Enclosure 2

UN#13-056

**Table of Changes to CCNPP Unit 3 COLA  
Associated with the Response to  
RAI 315, Question 03.07.02-64 (Part C),  
Calvert Cliffs Nuclear Power Plant, Unit 3**

**Figure 3E-2— {Reinforcement for Forebay and UHS Makeup Water Intake Structure Basemat}**

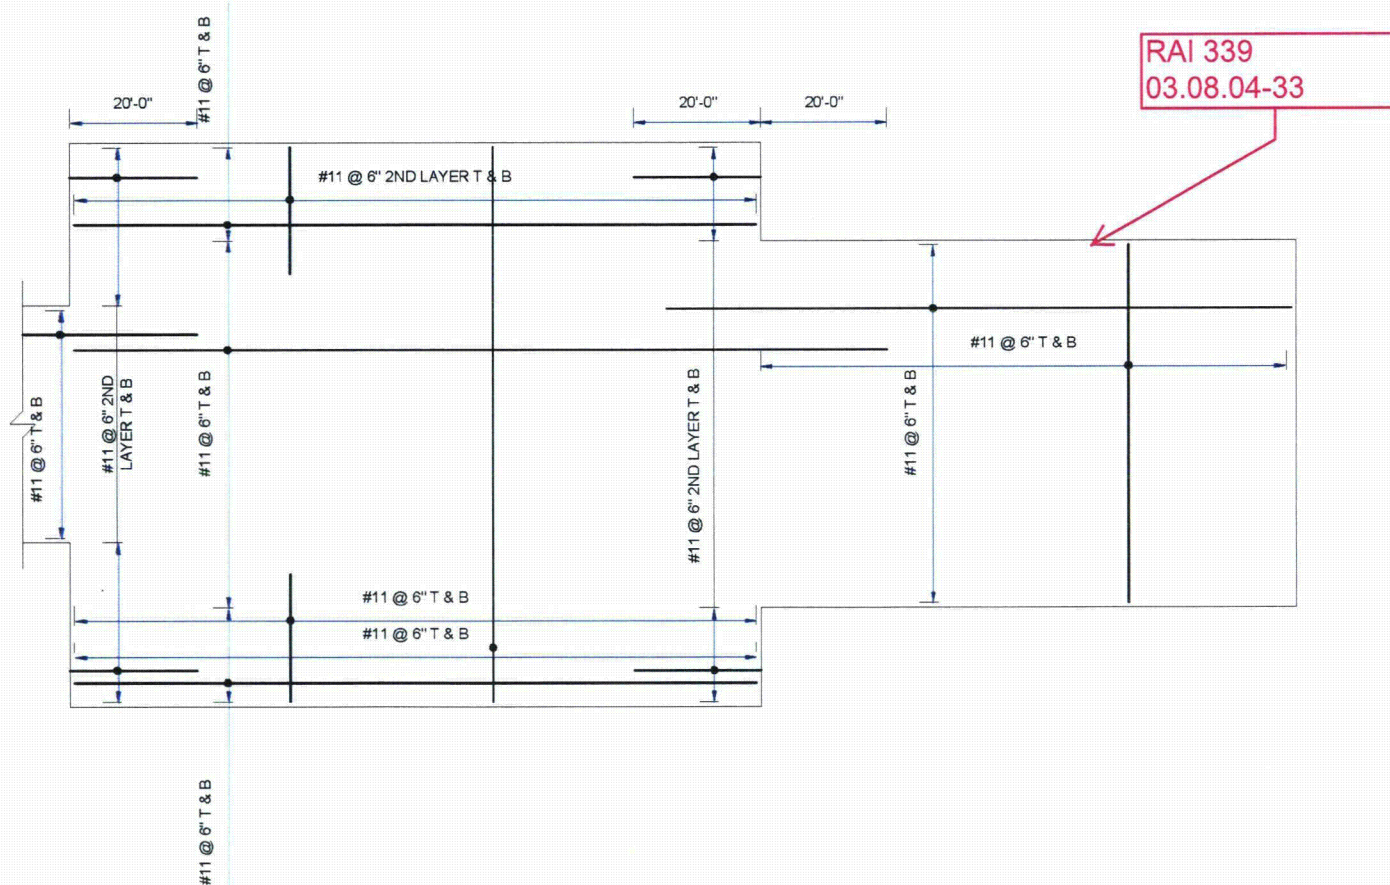
RAI 339  
03.08.04-33

**Figure 3L-4 — {Reinforcement for Forebay and UHS Makeup Water Intake Structure Walls - Forebay Long Wall (Section C)}**

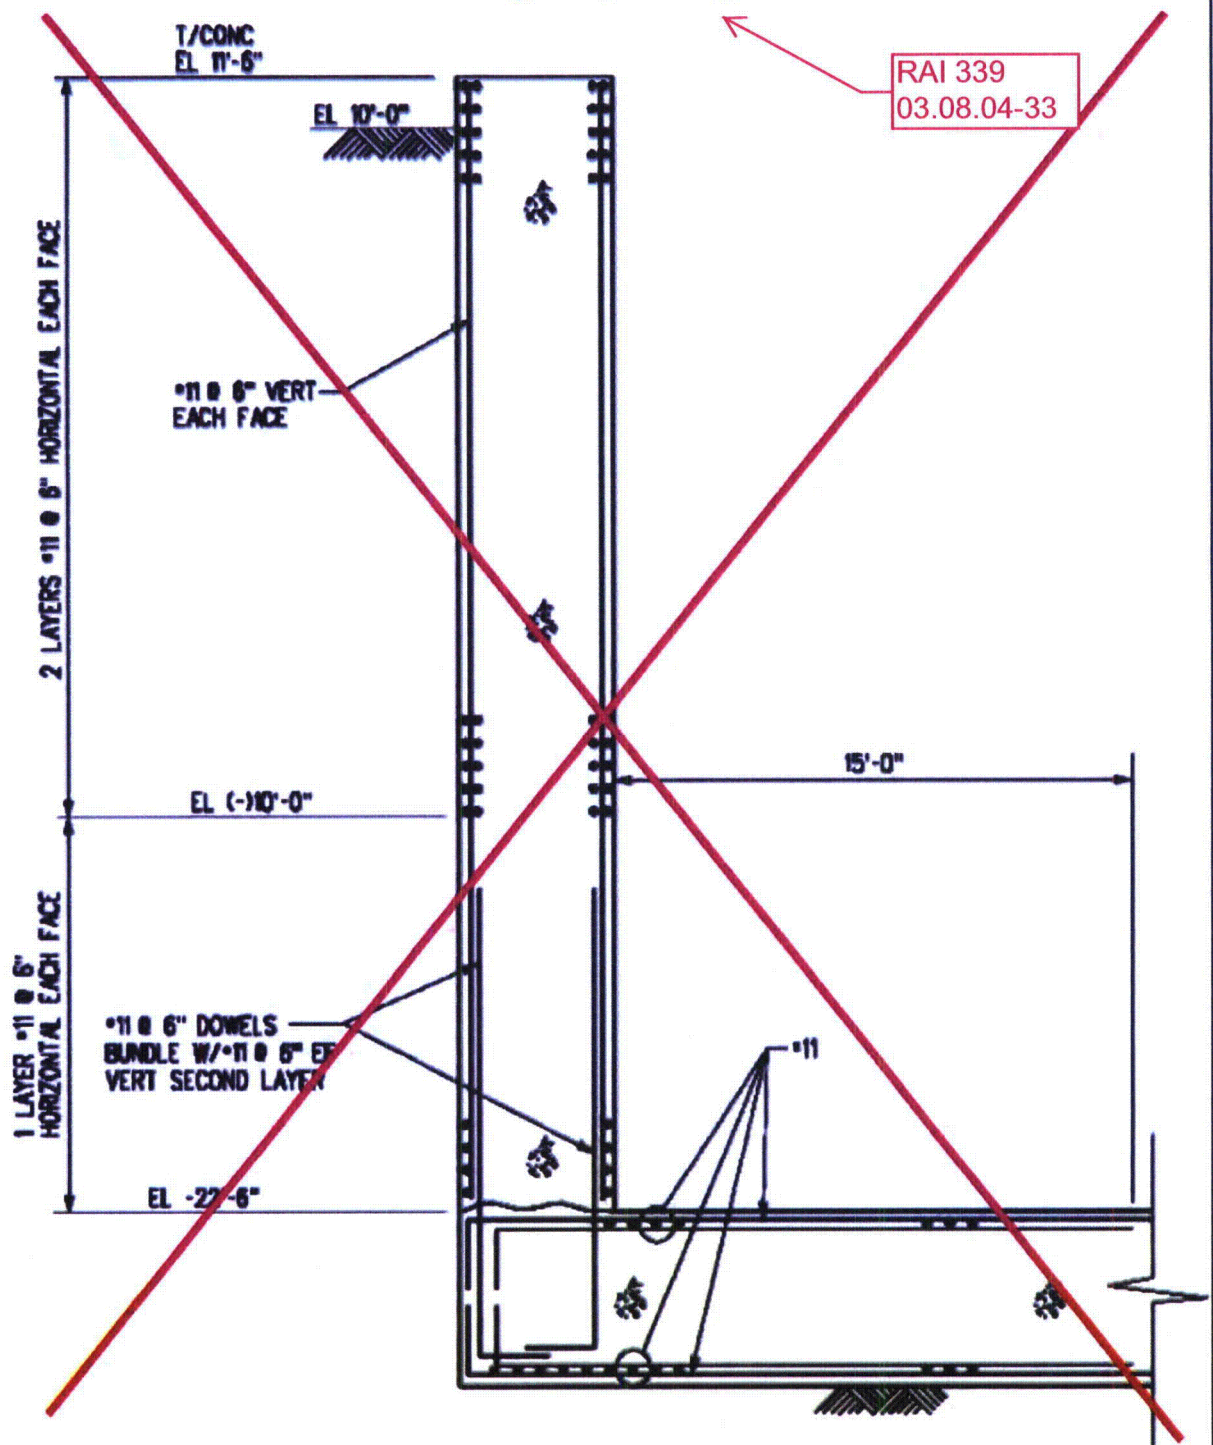
RAI 339  
 03.08.04-33

**Figure 3F-32 — {Shear Wave Velocity Profiles Strain-Compatible with Site SSE for the Intake Area}**

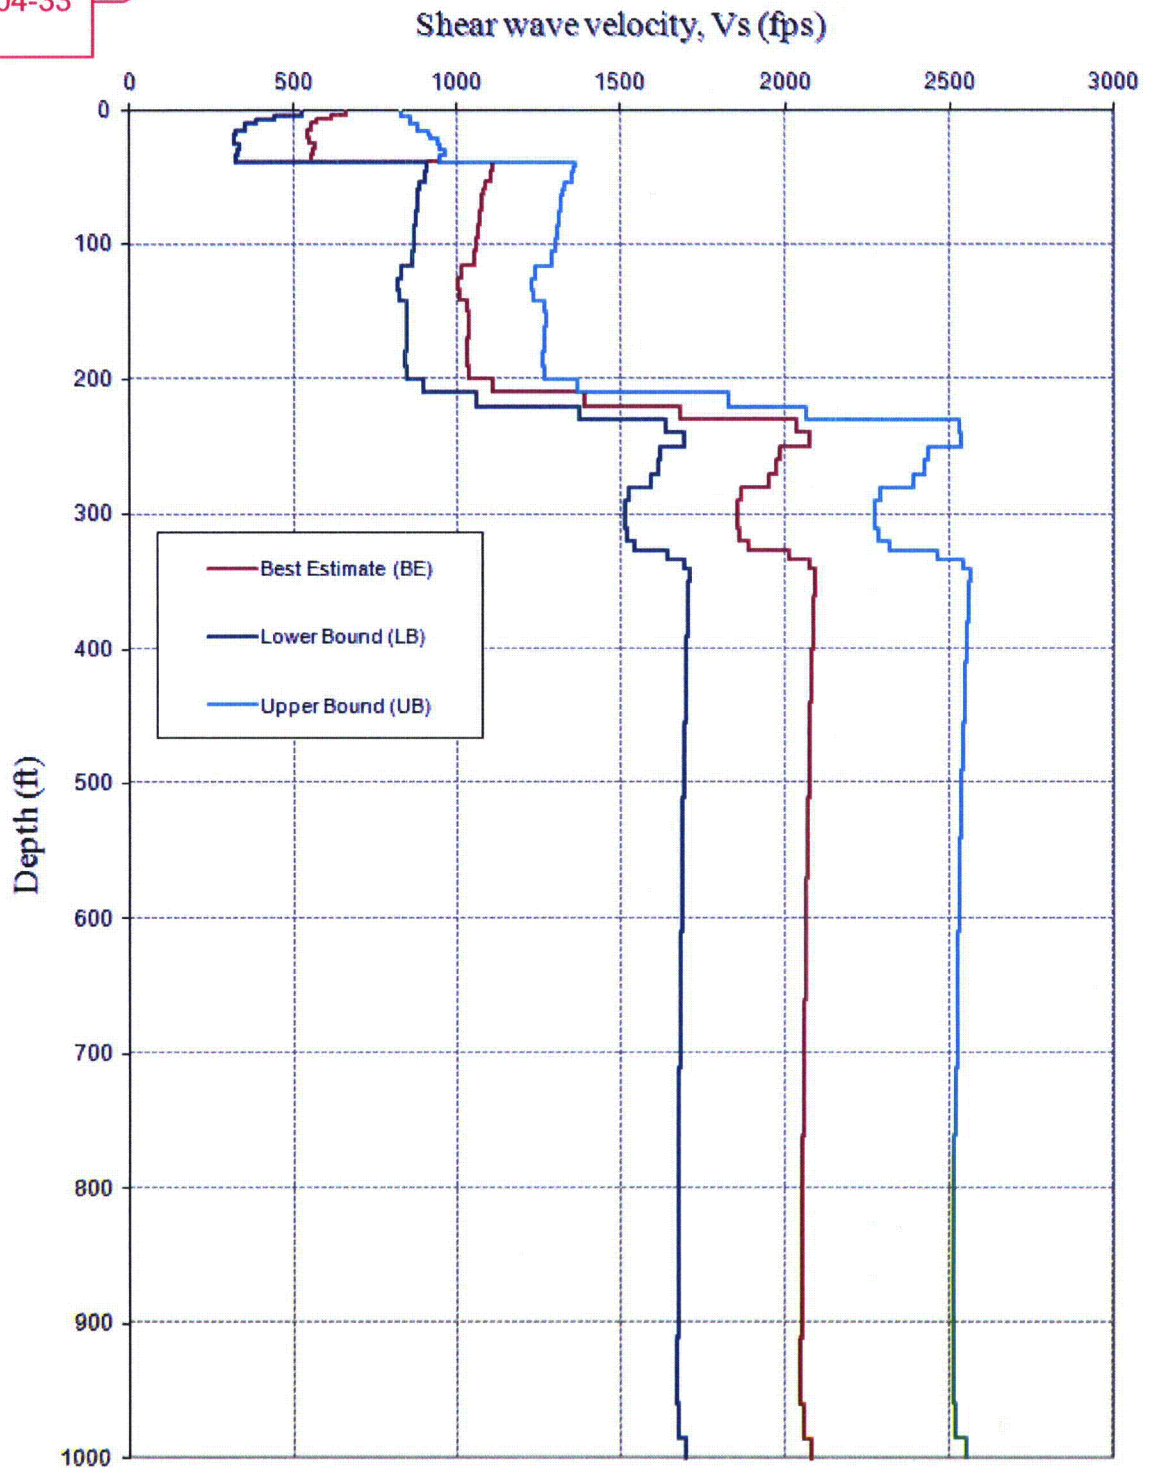
RAI 339  
 03.08.04-33

Figure 3F-33— {Damping Profiles Strain-Compatible with Site SSE for the Intake Area}

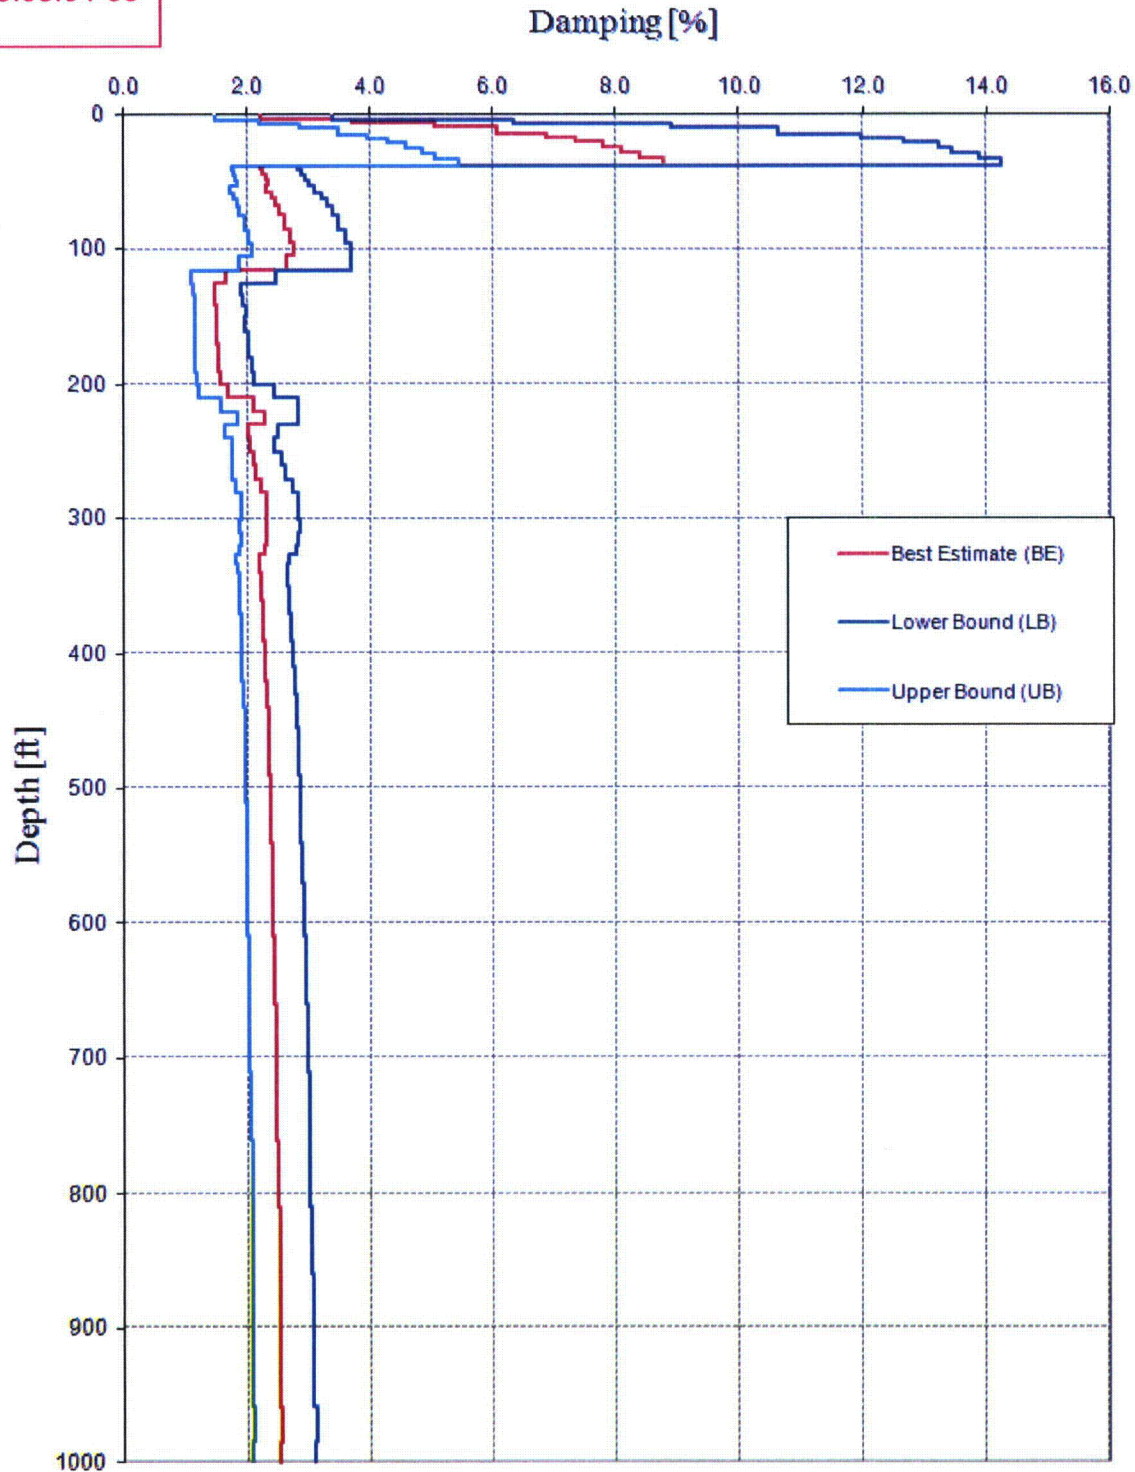
RAI 339  
 03.08.04-33
